# MARIN WOODS

DATE 08/22/2016 JOB NO. 15-243
RE: Marin Woods; PPL-15-01, PLN-18-09
Preliminary PRD 4th Submittal

Re: Marin Woods Preliminary Plat/PRD  
Response to City Comments dated March 28 and April 07, 2016, PLN-15-90, PPL-15-01

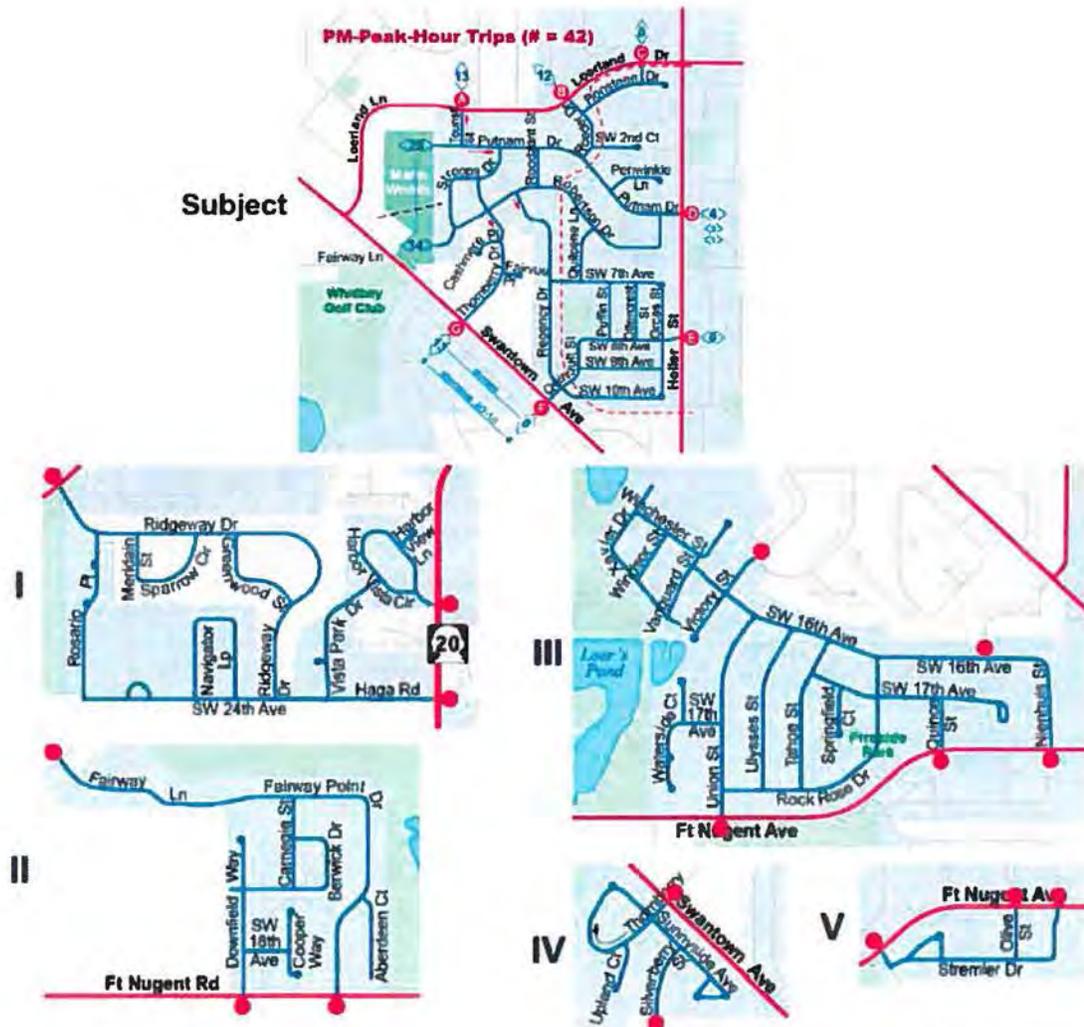
The PM-Peak-Hour Trips, 42 trips, flow 28 trips to Putnam, of which 13 trips exit the neighborhood via Tourist, and 12 trips via Roeder Drive, 3 trips via Putnam at Heller. The remaining 14 trips (see black dashed line on subject property) flow to Robertson, of which 13 trips exit the neighborhood via Thornberry [alternatively (per Gibson) 2/3 or 8 trips via Thornberry and the remainder (1/3 or 5 trips) via Regency] and 1 trip via Putnam.

All Gibson Traffic figures are peak-hour, meaning in all other hours of the day, counts are less. Forty-two trips per peak-hour is the equivalent of one trip about every ninety seconds, perhaps peak is not the most appropriate term.

The map also defines (red dashed line) a sub-area of the neighborhood which should have NO distinguishable impact whatsoever.

FIGURE 2

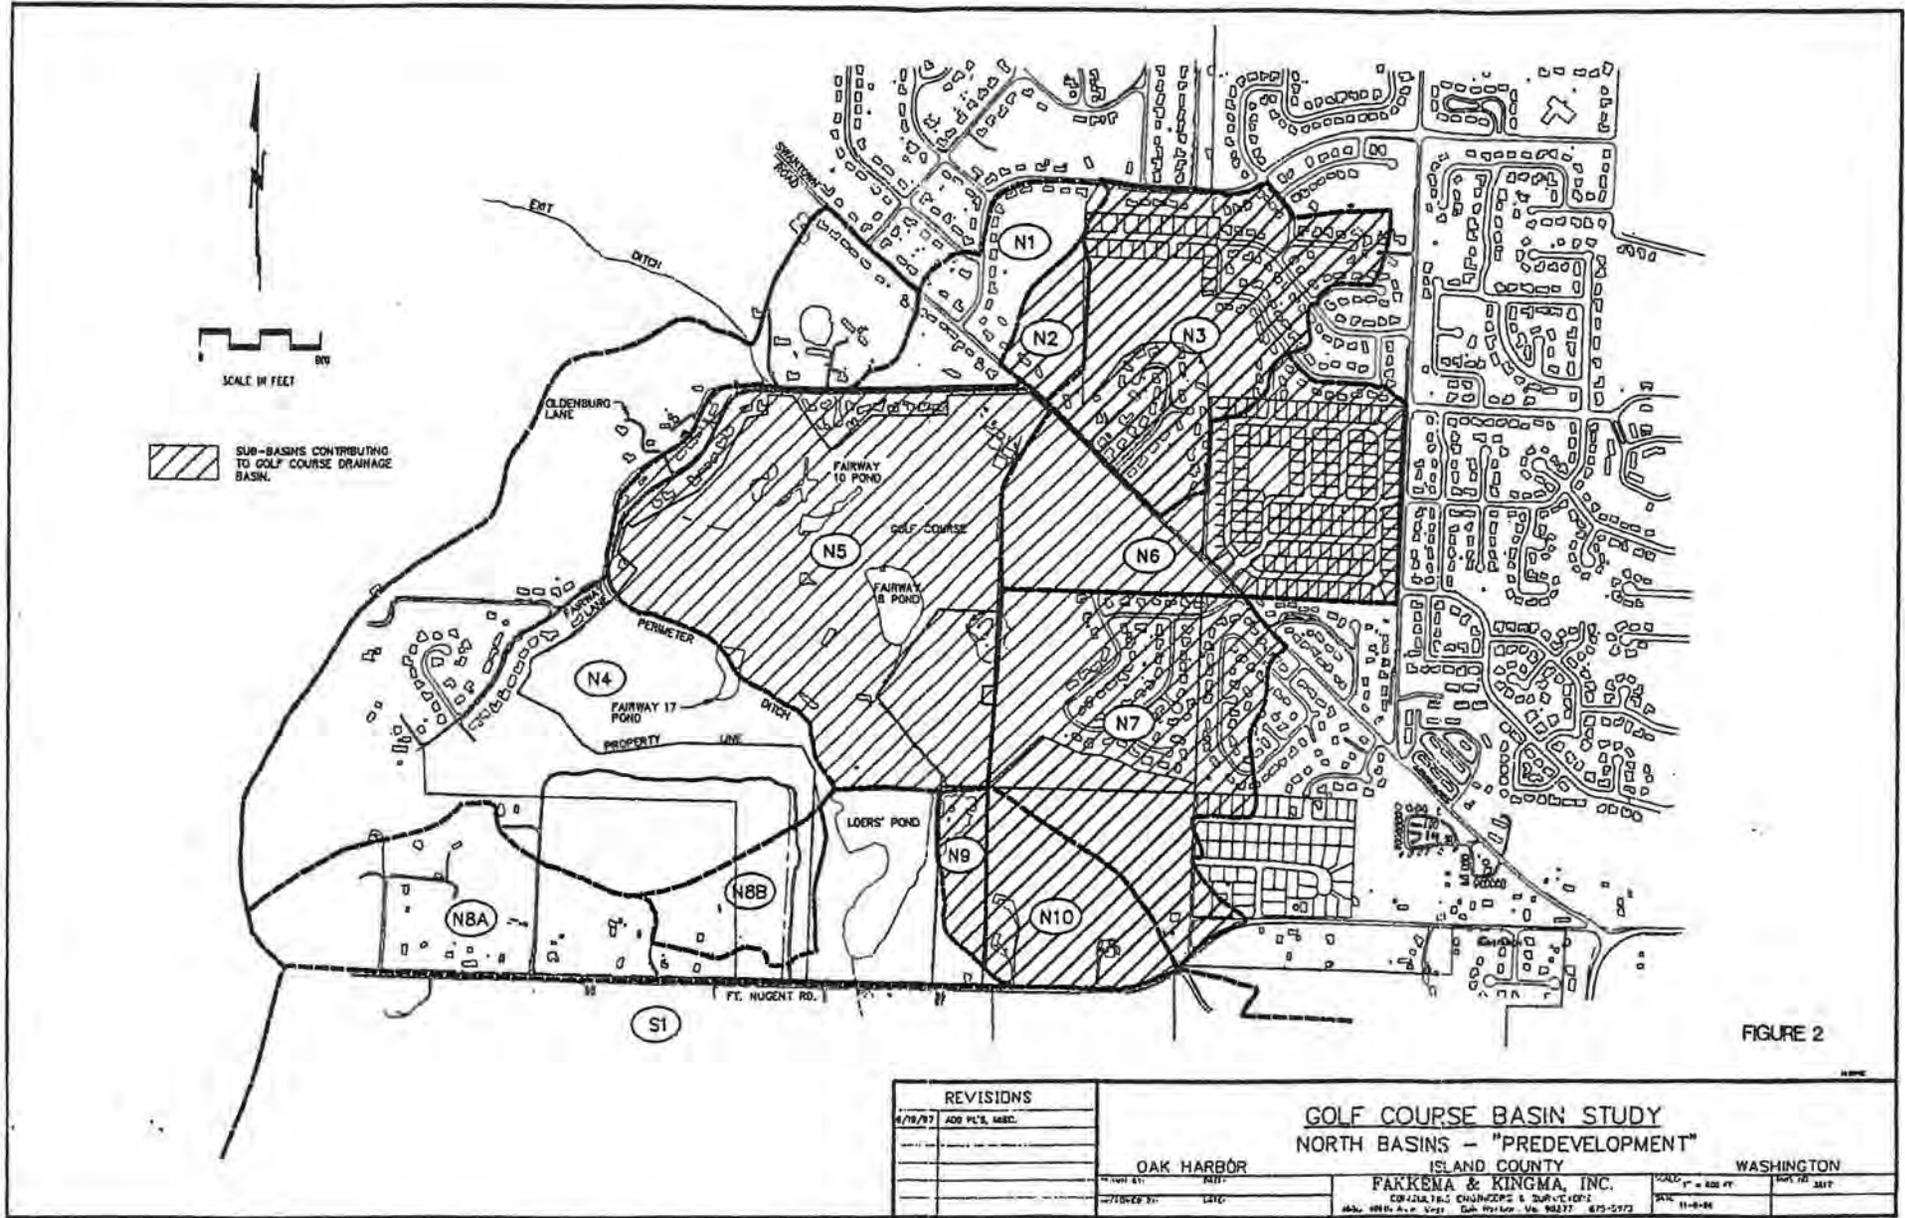
6. On page 9, we believe it would be helpful to show the Club's property line on this Figure and also on Figure 13 (page 31) and on Figure 1 (page 2).
7. On page 10, Figure 3 should show N8A flowing to the perimeter ditch and not to Loers Pond to be consistent with page 3. We realize a portion of this water flows to Loers Pond by means of the ditch along Ft. Nugent Road.

WGCC property lines added to Figures 1, 2, and 13.
